**METROPOLITAN GOVERNMENT OF NASHVILLE AND DAVIDSON COUNTY**

Metropolitan Historic Zoning Commission  
Sunnyside in Sevier Park  
3000 Granny White Pike  
Nashville, Tennessee 37204  
Telephone: (615) 862-7970  
Fax: (615) 862-7974

**STAFF RECOMMENDATION**  
**2002-2002 ½ Eastland Avenue**  
**August 20, 2014**

**Application:** Demolition; New construction-infill  
**District:** Eastwood Neighborhood Conservation Zoning Overlay  
**Council District:** 06  
**Map and Parcel Number:** 08306038400  
**Applicant:** John Root, architect  
**Project Lead:** Sean Alexander, sean.alexander@nashville.gov

ARCHITECTURAL SITE PLAN

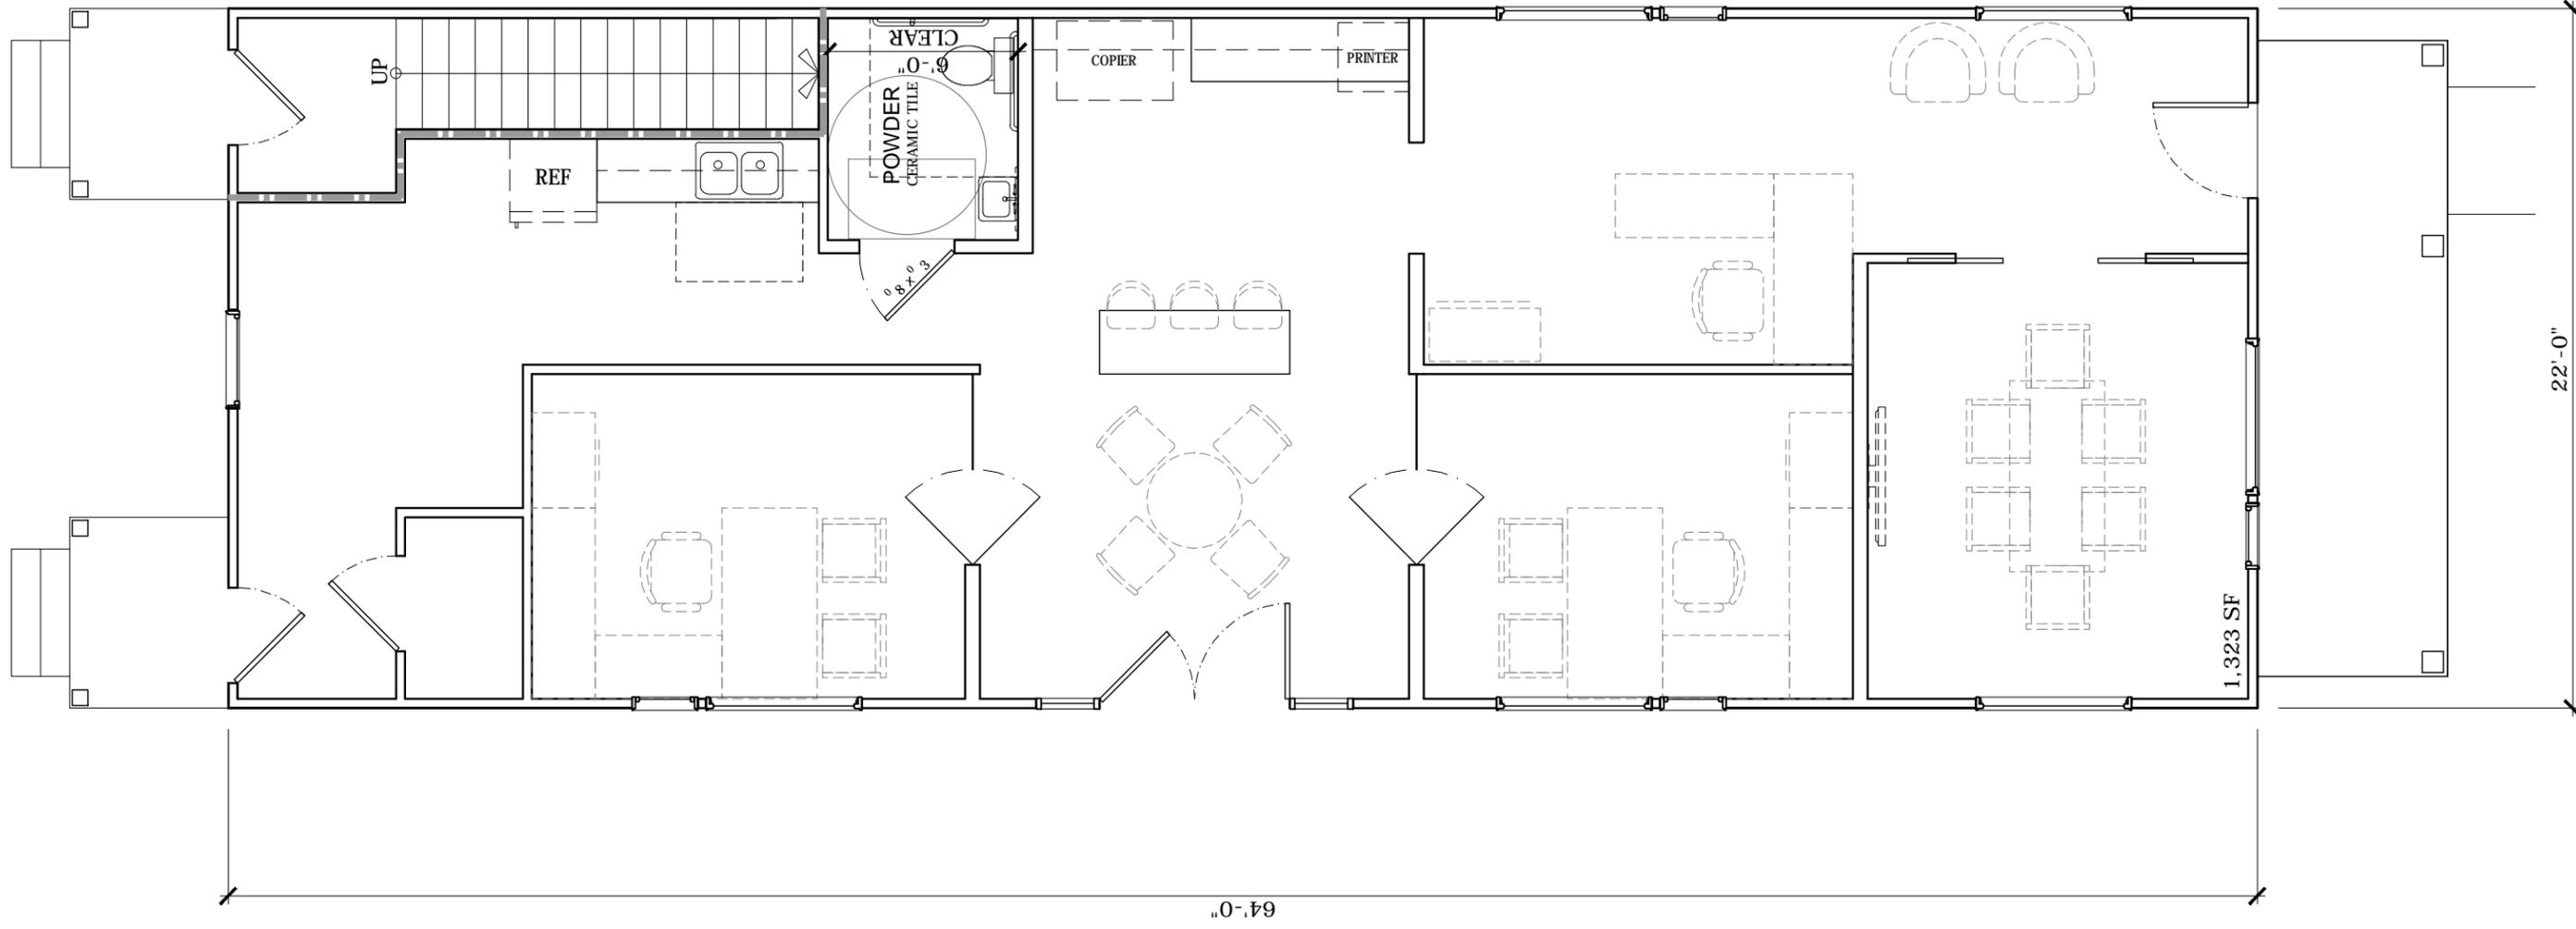
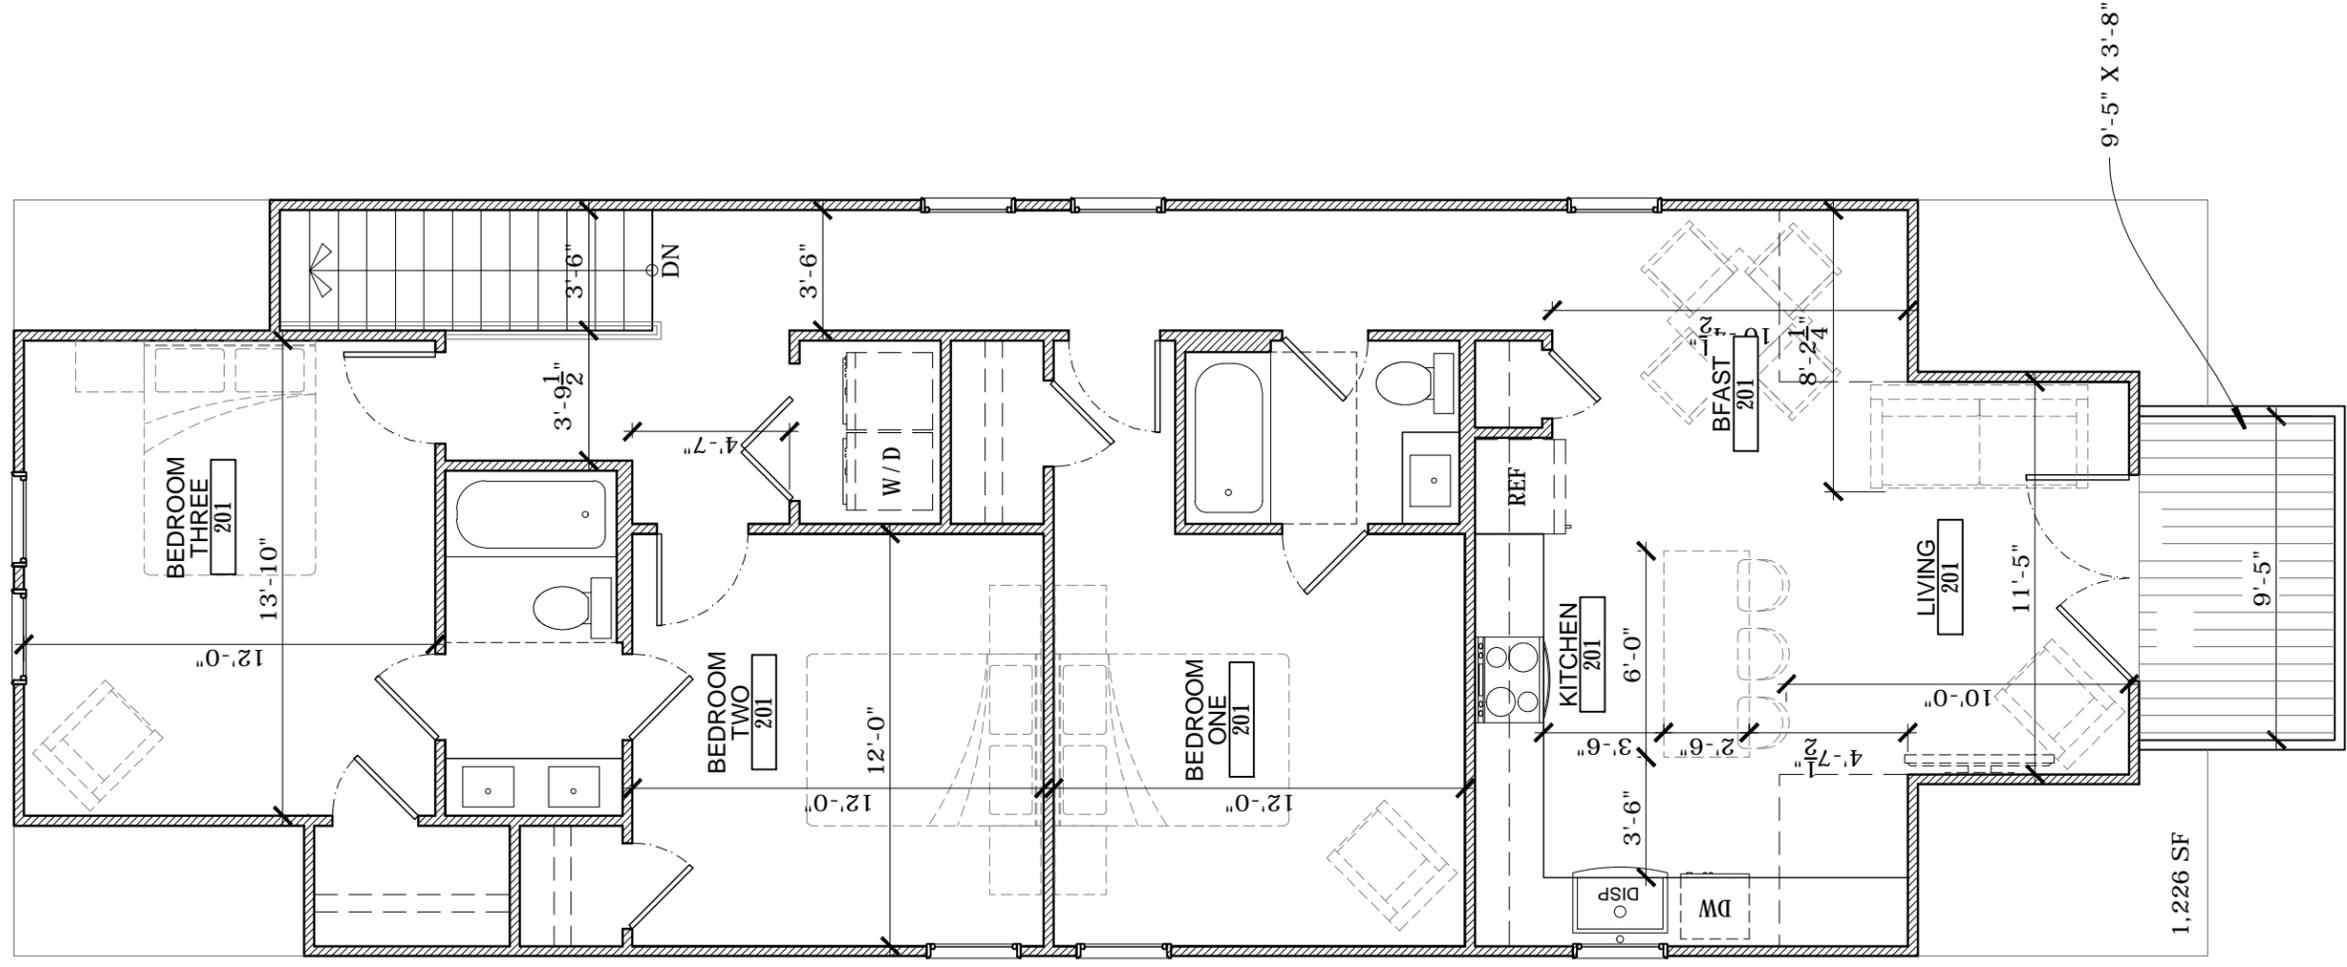
The new buildings will have front setbacks matching the two adjacent structures, both of which are contributing. The new buildings will have a right side setback of three feet (3'), a left side setback of eighteen inches (18"), and twelve feet (12') of space between them. Staff finds that these side setbacks, to the extent possible given the size of the lot, would maintain the rhythm of spacing between existing buildings on the street. The side setbacks also meet the MUN-A bulk zoning regulations, for which no setback is required for mixed-use structures. Staff finds these setbacks to be appropriate and to meet section II.B.1.c.

Because of the upperstory residence, Building and Fire codes may require a greater side setback buffer. With a new site plan, staff could approve an increased side setback if necessary.

The location and orientation of the proposed new buildings will be similar to the adjacent historic houses with a front-facing, six foot (6') deep front porch and a walkway from the porch to the street. However, the proposed buildings would have a shared street-loaded

parking area in front of the buildings, in addition to a parking area at the rear. Staff finds that the introduction of front-yard parking, when an accessible alley is present, is not appropriate. With a condition that the project not have front-yard parking, staff finds that the project meets section II.B.1.f.

1. The finished floor height shall be consistent with the finished floor heights of the adjacent historic houses, to be verified by MHZC staff in the field;
2. Staff approve the roof colors and the final details, dimensions and materials windows and doors prior to purchase and installation;
3. Staff approve the materials of the porch floor and front steps;
4. The proportions of the side windows are more in keeping with a residential form;
5. There shall not be a front-yard parking area.

STREET ELEVATIONS

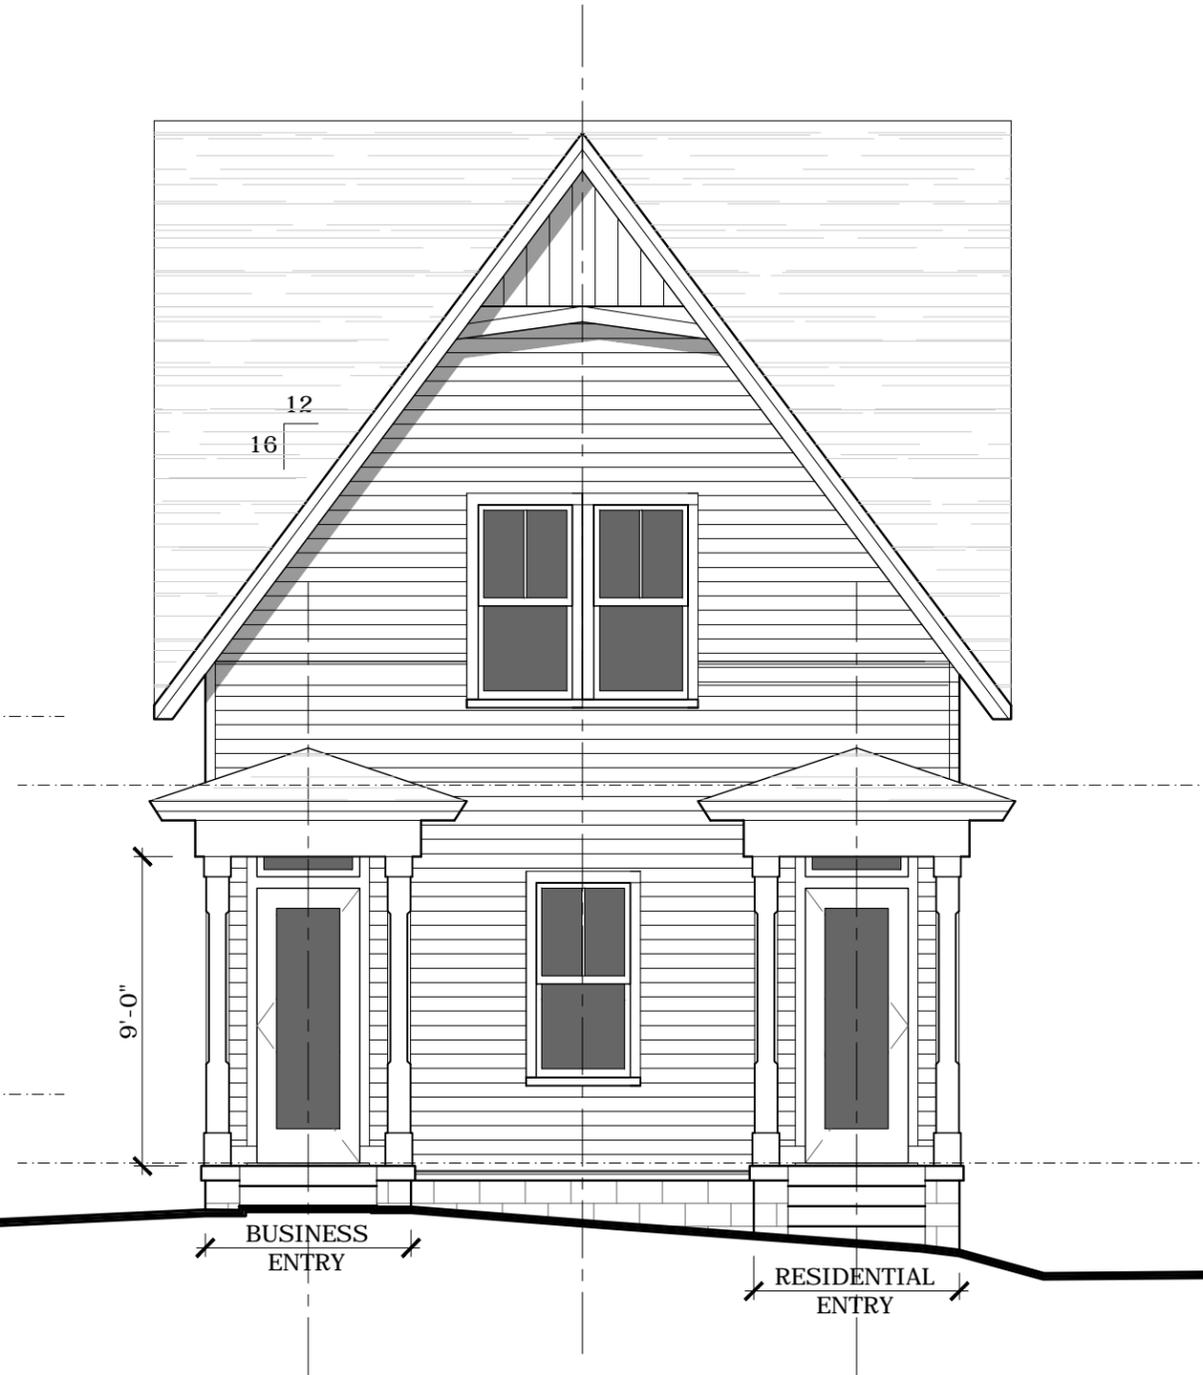
The two new structures to be built on the lots will be one and one-half stories tall, which matches the number of stories of surrounding historic buildings. They will have side-gabled roofs with ridges at thirty-three feet (33') above grade. Within this total height the buildings will have a floor height of two feet, six inches (2'-6") above grade and an eave height of nine feet, six inches (9'-6") above the floor level. The heights of the new buildings will be compatible with surrounding historic houses, most of which are also one and one-half stories and range from twenty-two feet (22') to thirty-three feet (33') tall. Staff asks to verify that the height of the finished floor is constructed as proposed before framing begins.

The new buildings will primarily be clad in smooth face cement fiberboard with a reveal of five inches (5"), vertical siding in the gable fields and shingles on the dormer. The material of the vertical siding and shingle siding is not known. The trim and porch columns will be wood. The material of the porch floor and front steps is not known. The foundations will be split-faced concrete block, and the primary roofs will be architectural fiberglass shingles with metal on the porch roofs. The roof colors are not known. The windows and doors will be wood, and staff asks to approve the final window and door selections prior to purchase and installation. With the staff's final approval of the roof color, porch materials, vertical siding and shingle siding material, and the windows and doors, staff finds that the known materials meet guideline II.B.1.d

The new buildings will have asymmetrical side-gabled roofs, 12:12 pitched on the front slope and 5:12 on the rear. The buildings will be differentiated by 16:12 pitched front-projecting gable on the front of the left building and a 4:12 pitched shed dormer on the building on the right. The projecting gable and shed dormer will both have an open balcony on the front. Although these particular roof components would not typically be found together historically, the individual elements and pitches are common to historic houses and the rear slopes will be minimally visible from the street. Staff finds their contemporary configuration in this project meets section II.B.1.e.

The windows on the first story of the building will be commercial-type casements or fixed windows, and the upperstory windows will be double-hung sash windows. Although the building is mixed-use, the overall character of the buildings read as residential and as such the windows should be compatible with the proportions of windows on historic houses. The front windows are modern interpretations of a front “picture” window with two side-lights seen on some buildings as early as the 1930s and 1940s; however, this is an inappropriate window for the side elevations. Staff recommends that all side windows be twice as tall as they are wide, as is typical of historic openings. There are no large expanses of wall space without a window or door opening. With a condition that the windows are vertically oriented, staff finds the project’s proportion and rhythm of openings would meet Section II.B.1.g.
